Permit Application No.: 17-561

Applicant:Edina Public SchoolsProject:South View Middle School Addition and Bus ParkingLocation:4725 South View Lane, Edina

#### Background

Flooding Areas in the South Minnehaha Creek Subwatershed Excerpt from Edina Surface Water Management Plan (2018 DRAFT)

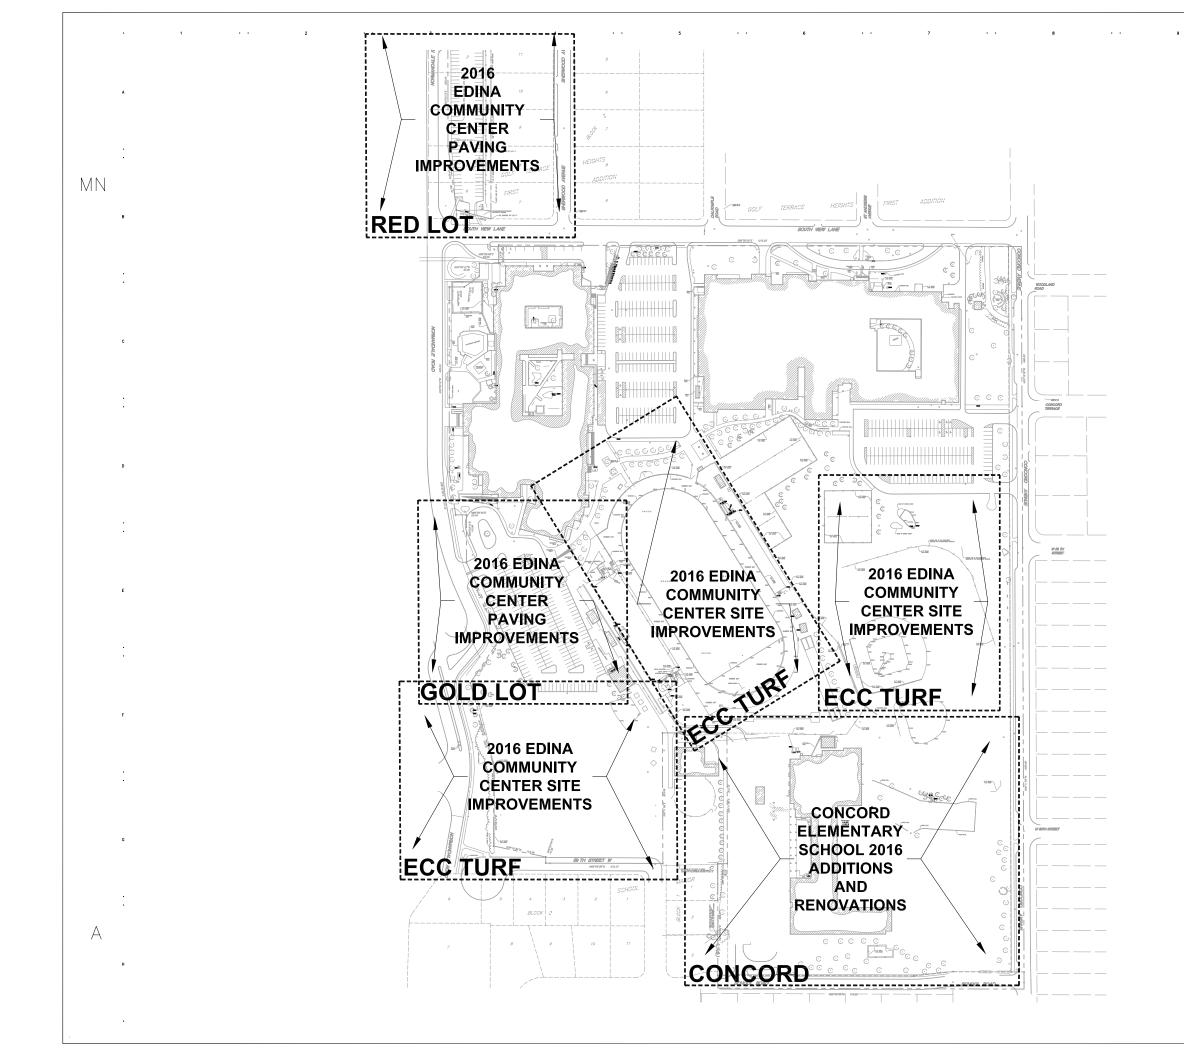
## Resident Concern

As mentioned in the introduction, a member of the public expressed concern regarding flooding in the area around proposed project. While the District may not require applicants to incorporate additional treatment criteria, staff and the District Engineer evaluated the proposal for impacts to localized flooding. Substantial flooding occurs upstream and downstream from the proposed new impervious area. The City of Edina has identified flooding in the 10 and 100 year events due to undersized storm sewers in the residential area north of the school (Area A) and at the intersection of Concord Avenue and 58<sup>th</sup> Street to the east of the school (Area B) as shown in Attachment 4. The total runoff volume for the site into the stormsewer will be maintained or reduced at all storm events, see Table 3 below. The proposed project will therefore maintain or reduce runoff rates and volumes to the downstream stormsewers lacking capacity.
